TWR-PROTO Module Errata

Figure 1 - TWR-PROTO - Impacted Area

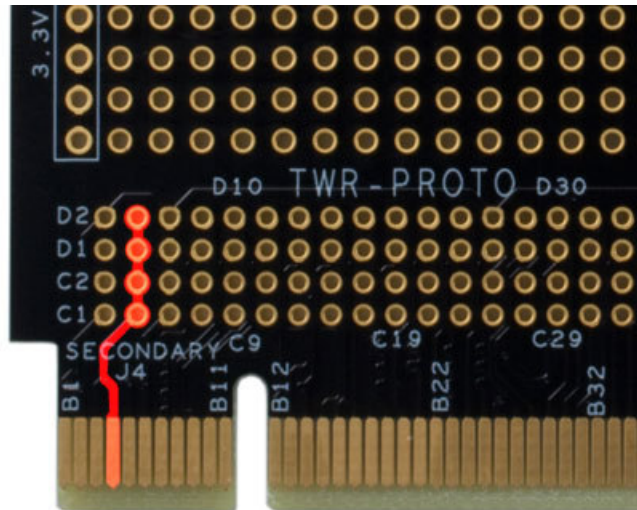
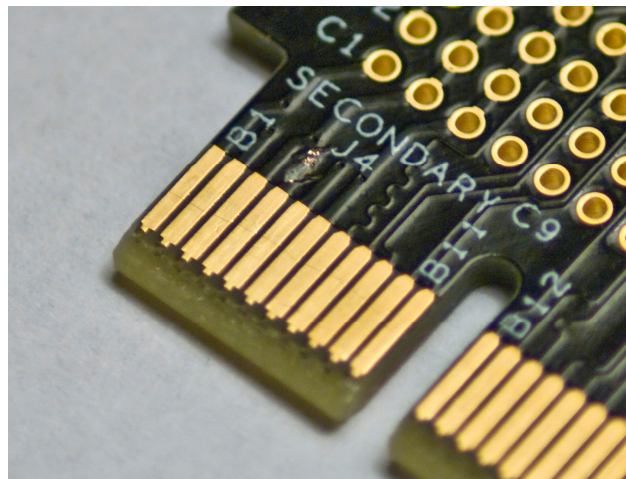
The following issue has been discovered with the secondary PCI edge connector on the TWR-PROTO Rev. A boards. The Power Sense signal on the secondary side of the edge connector is tied directly to the 3.3V signals on both the primary and secondary edge connectors. The Power Sense Signal is located on Pin B4 on both the Primary and Secondary edge connectors.

The Power Sense signal is also connected to B4 and D4 on the TWR-PROTO Primary and Secondary Connector Signal Access areas. The D4 (Secondary Connector Signal Access) is connected directly to the 3.3V signals.

This issue has the potential of connecting the 5V Power Sense signal to the 3.3V power supply if the TWR-PROTO module's secondary edge connector is inserted into a functional TWR-ELEV.

Figure 1 shows the impacted area of the TWR-PROTO module. The B4 edge connector pin on the secondary side is connected to B3 edge connector pin and C3, C4, D3, D4 of the Secondary Connector Signal Access.

The Power Sense signal on the secondary edge connector should be cut. This will isolate the 3.3V rail from the 5V Power Sense signal. Note that D4 in the Secondary Connector Signal Access will no longer be connected to the Power Sense signal and should be considered a 3.3V signal.

Figure 2 show a TWR-PROTO board that has been correctly modified to isolate the B4 edge connector pin from 3.3V signals.
